Access Compliance Report

Public Rights-of-Way

(Curb Ramps)

Intersection ID: 51379	Main Street: BROADRICK_BV	Cross Street: UNIVERSITY_CITY_BV	Location:	E
ADA ID: 2540FE59230A	Ramp Type: Perp	Initial Pass/Fail: Fail	Overall Compliance: No	Severity Score: 25
Codes/Mitigation Info/Possible Solution		Field Measurements/Component Compliance

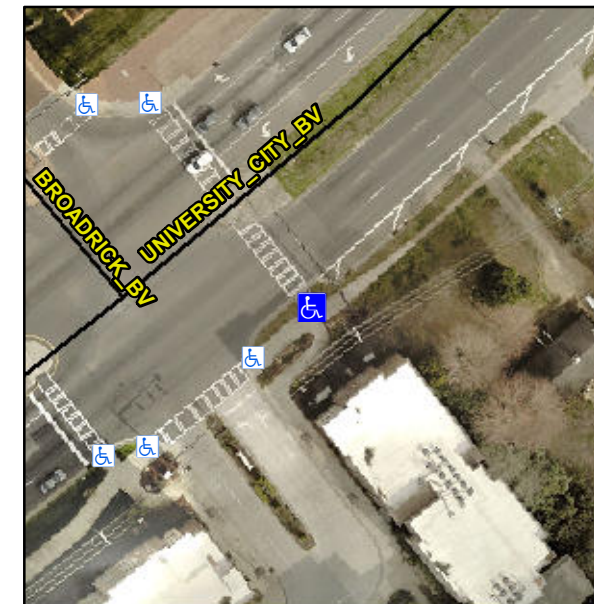
R304.2.2

Compliance	Description	Data	Compliance	Description	Data
N/A	Ramp Length (in)	93.5	No	Ramp Slope (%)	14.4
Yes	Ramp Width (in)	96.0	Yes	Ramp XSlope (%)	0.8
N/A	Flare Type LT	N/A	N/A	Flare Type RT	N/A
N/A	Flare Slope LT (%)	N/A	N/A	Flare Slope RT (%)	N/A
N/A	Flare Traversable LT?	N/A	N/A	Flare Traversable RT?	N/A
N/A	Landing Length (in)	N/A	N/A	DWS Provided?	N/A
N/A	Landing Width (in)	N/A	N/A	DWS Contrast?	N/A
N/A	Landing Slope (%)	N/A	N/A	DWS Length (in)	N/A
N/A	Landing X Slope (%)	N/A	N/A	DWS Full Width?	N/A
N/A	Landing Curb? (Y/N)	N/A	N/A	DWS Offset (in)	N/A
N/A	Shared Landing?	N/A			
N/A	Gutter Ponding?	N/A	N/A	Gutter Slope (%)	N/A
N/A	Gutter Lip Ht (in)	N/A	N/A	Gutter X Slope (%)	N/A
N/A	Painted X Walk1?	Yes	N/A	Painted X Walk2?	N/A
	X Walk 1 Direction	To NW		X Walk 2 Direction	N/A
N/A	X Walk 1 Width (in)	120.0	N/A	X Walk 2 Width (in)	N/A
	X Walk 1 Slope (%)	1.8		X Walk 2 Slope (%)	N/A
	X Walk 1 X Slope (%)	0.5		X Walk 2 X Slope (%)	N/A

Remove & Replace Entire Ramp.
